TVA-SQN-TS-05-02

**SEQUOYAH NUCLEAR PLANT (SQN) - UNITS 1 AND 2 - TECHNICAL
SPECIFICATIONS (TS) CHANGE 05-02 "CYCLIC AND TRANSIENT
LIMITS WITH DESIGN FEATURES REVISION"**

Proposed Technical Specification Changes (mark-up)

FIGURE 5.1-1

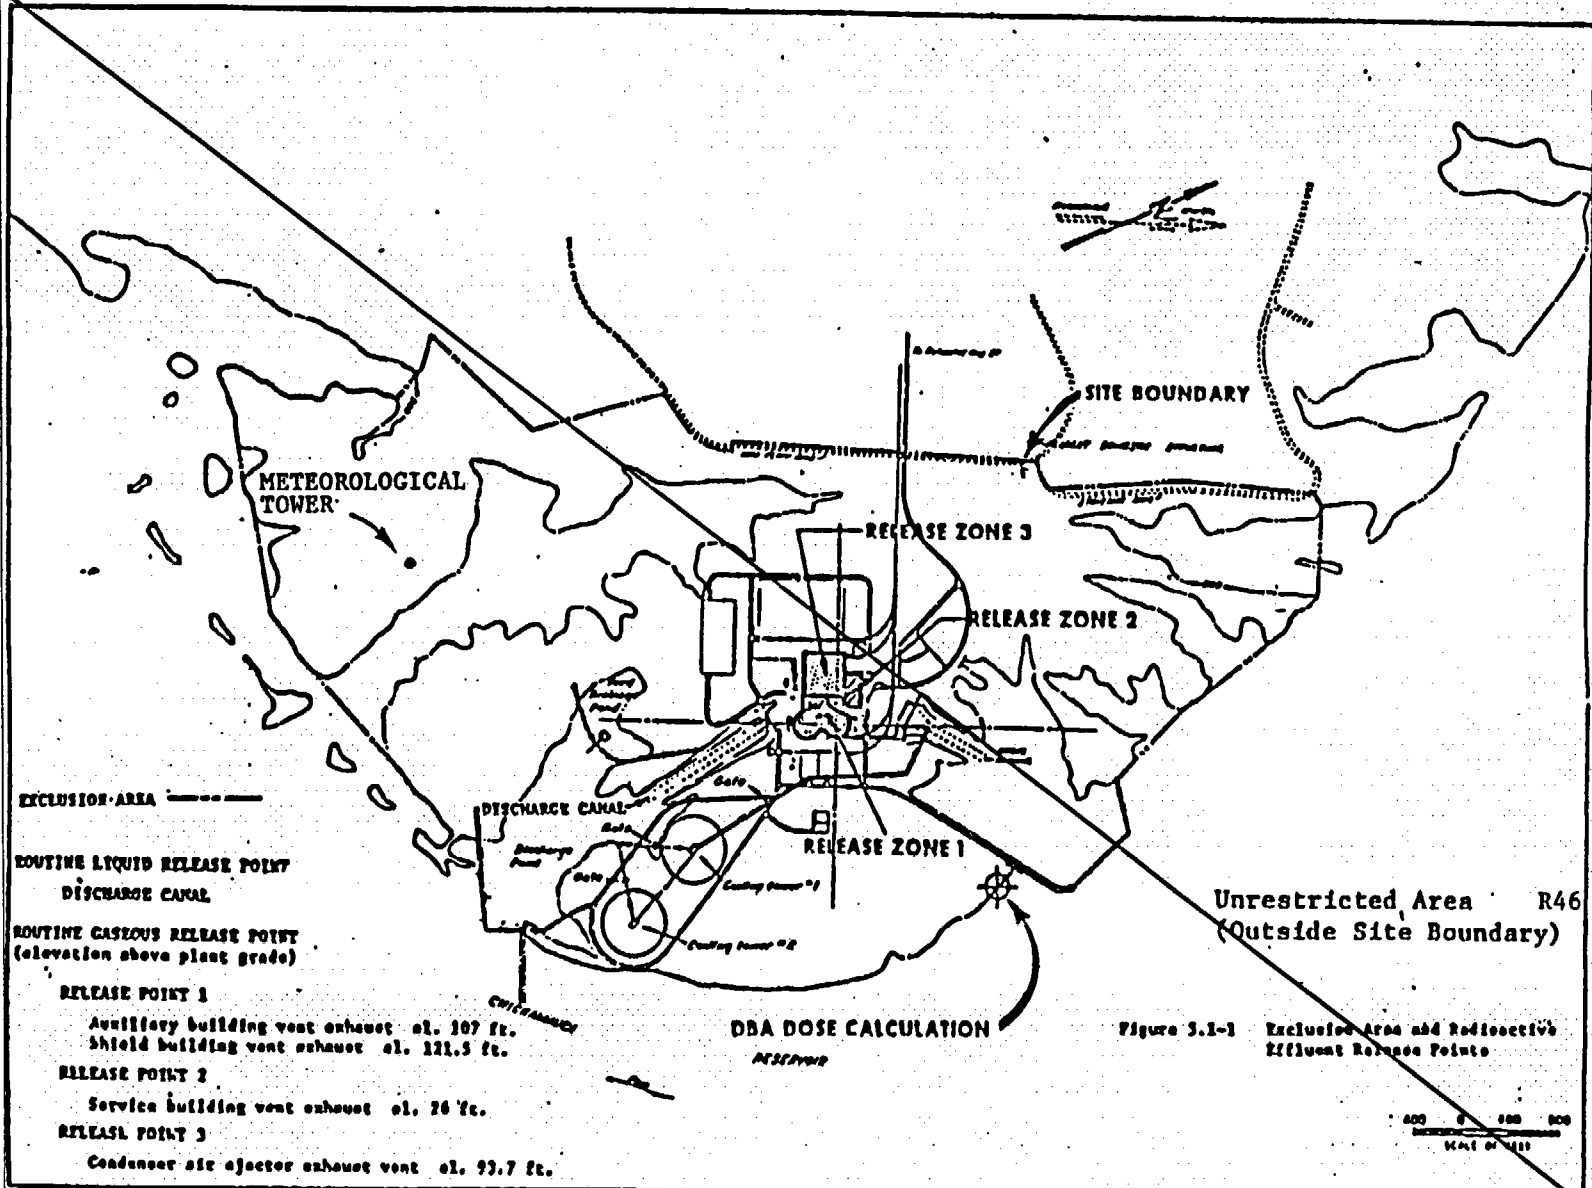
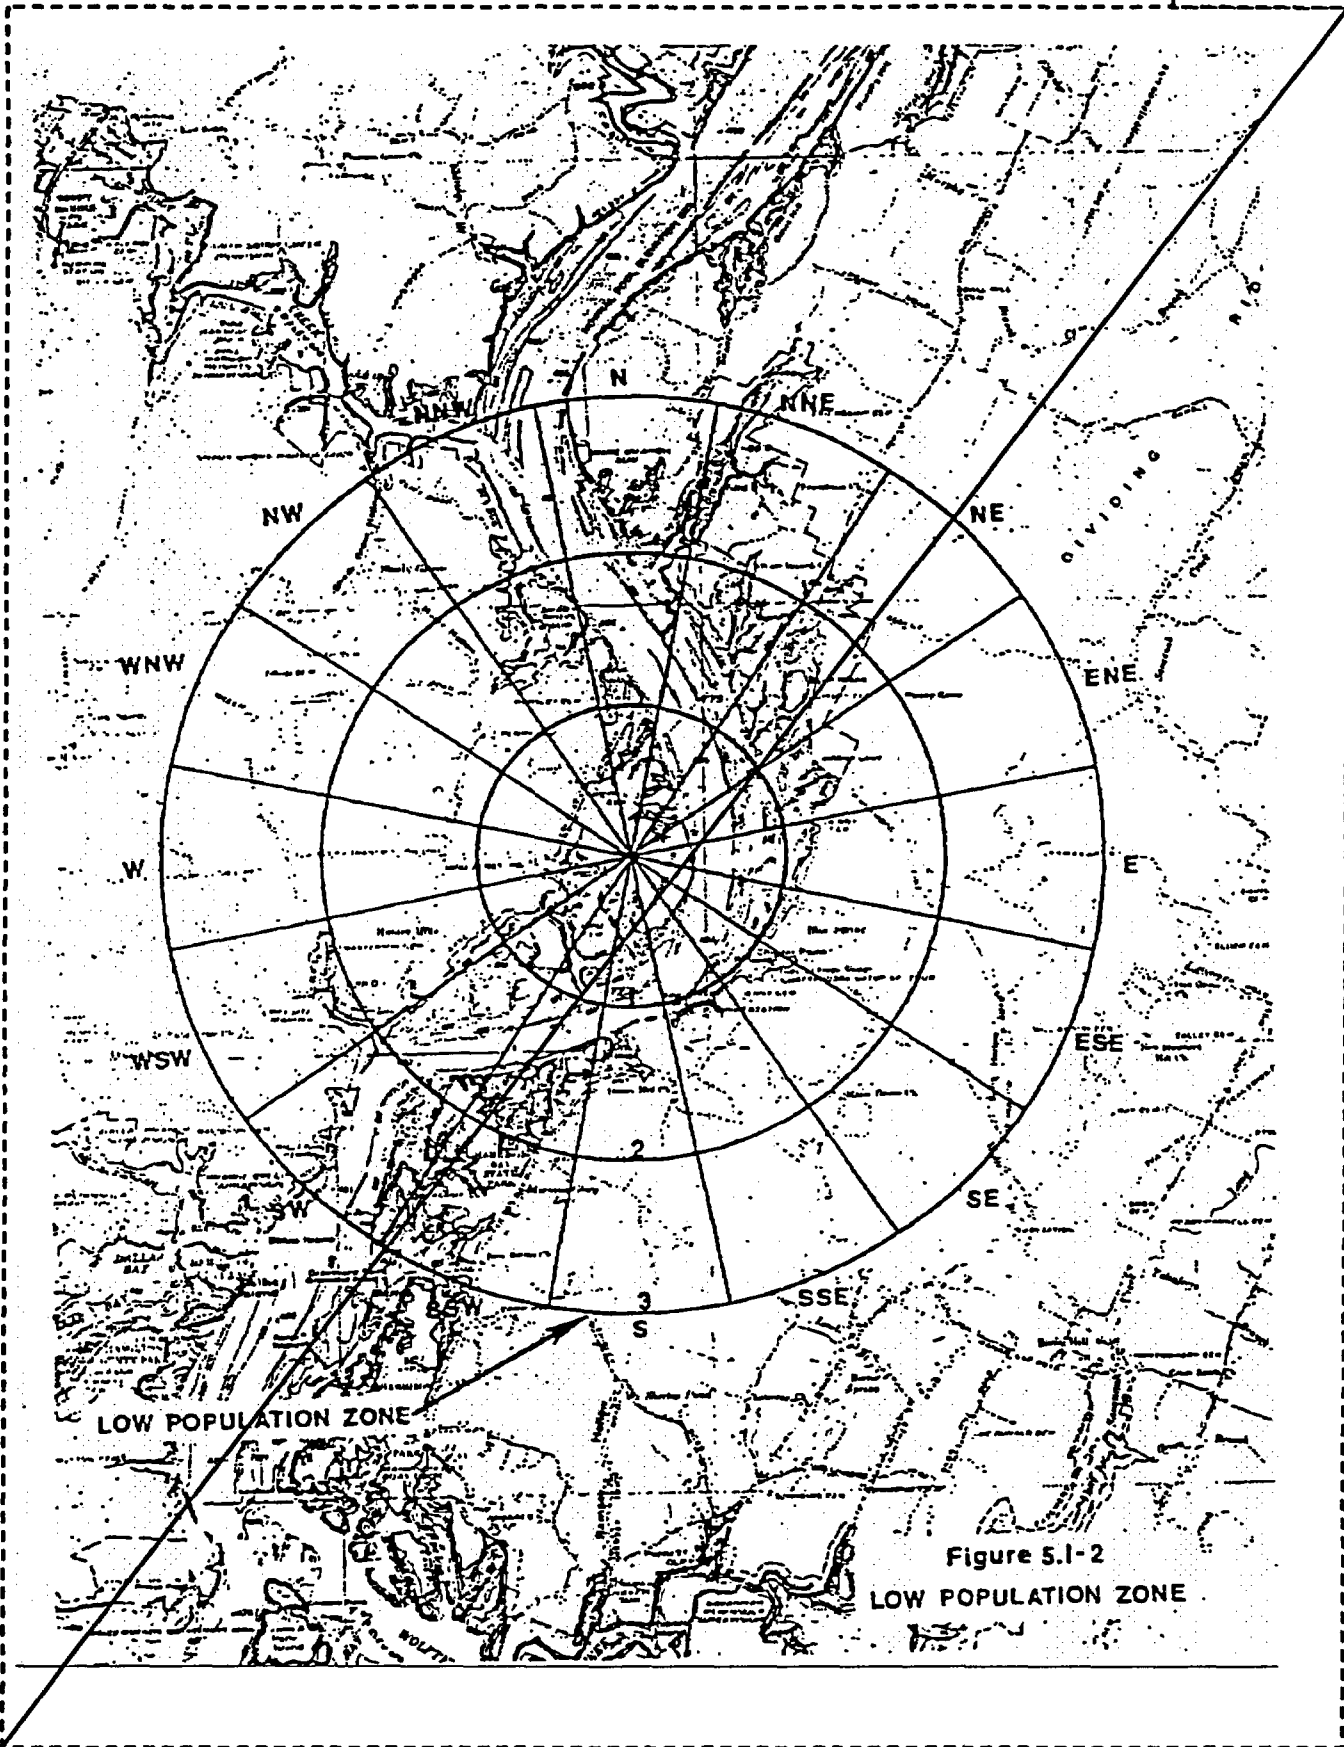
Included within Section 5.1, subsections Exclusion Area, Low Population Zone, Site Boundary for Gaseous Effluents, and Site Boundary for Liquid Effluents will be eliminated including associated Figures 5.1-1 "Exclusion Area," and 5.1-2, "Low Population Zone." Each of these subsections will retain their title (i.e., "Exclusion Area"), however; text is added to indicate the sections are deleted. The title of

5.1.1 The exclusion area shall be as shown in Figure 5.1-1. ~~DELETED~~

5.1.3 The site boundary for gaseous effluents shall be as shown in Figure 5.1-1. ~~DELETED~~

5.1.4 The site boundary for liquid effluents shall be as shown in Figure 5.1-1. ~~DELETED~~

5.5.1 ~~The meteorological tower shall be located as shown on Figure 5.1-1. DELETED~~

Figure 5.1-2
LOW POPULATION ZONE

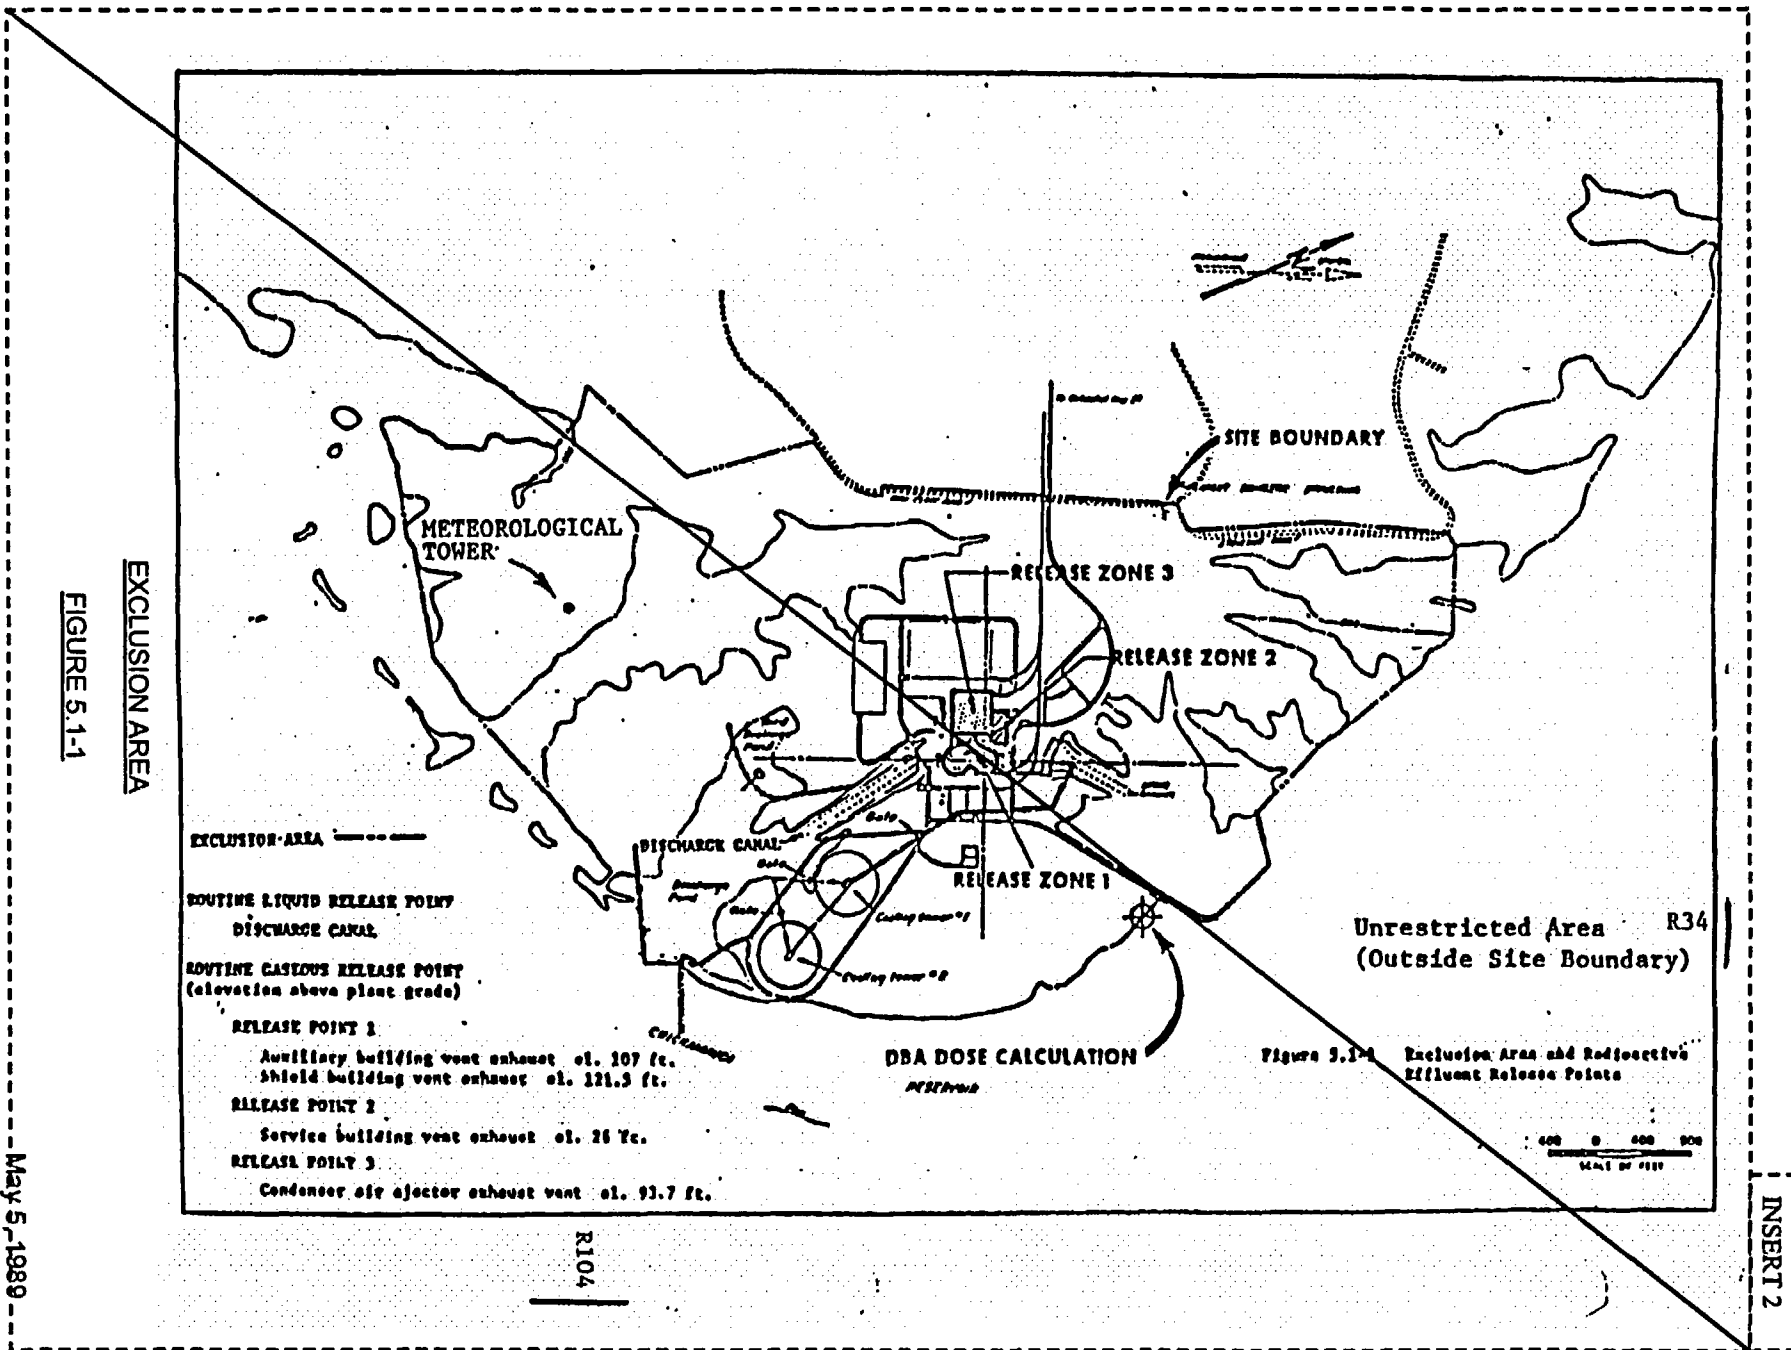
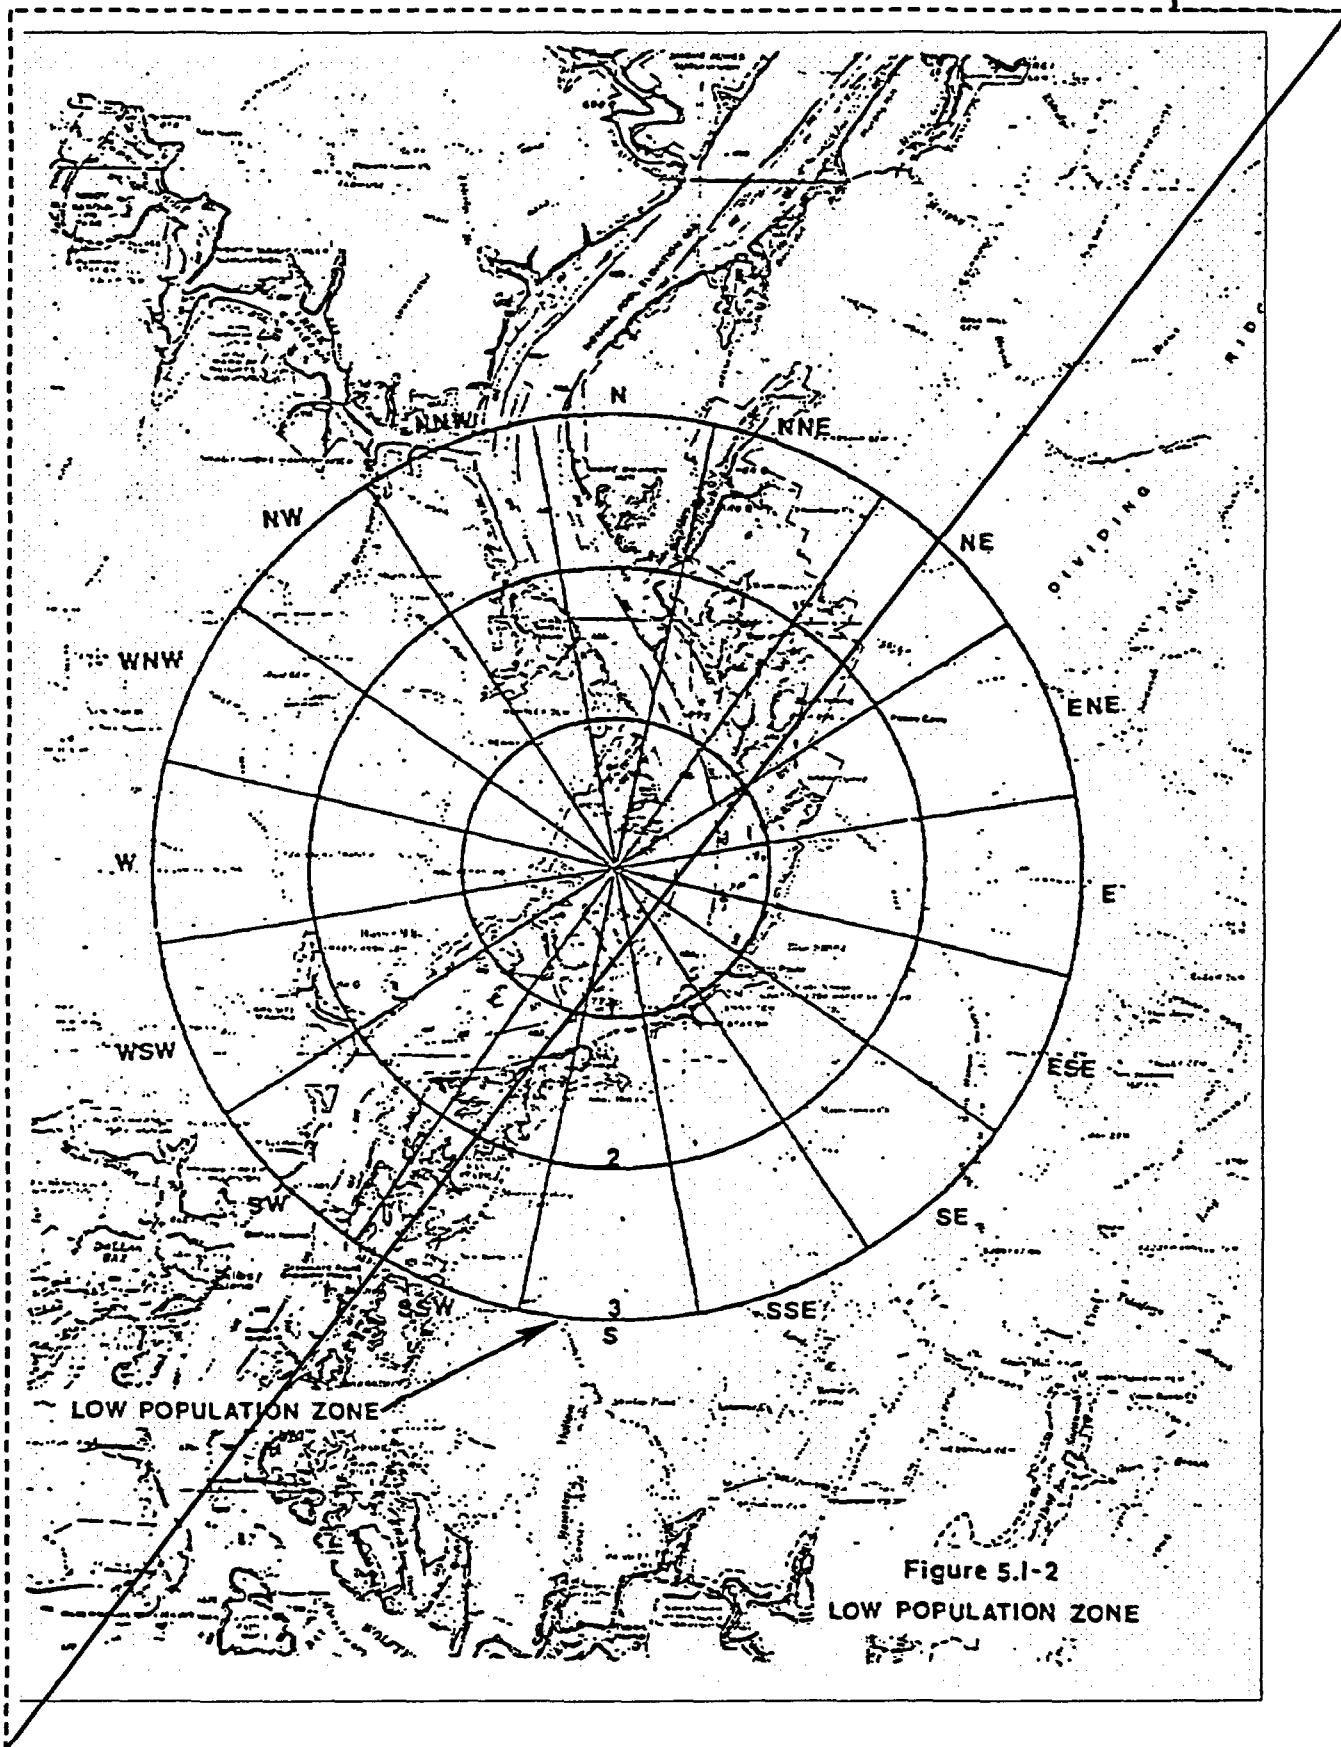
5.1.2 The low population zone shall be as shown in Figure 5.1-2. ~~DELETED~~
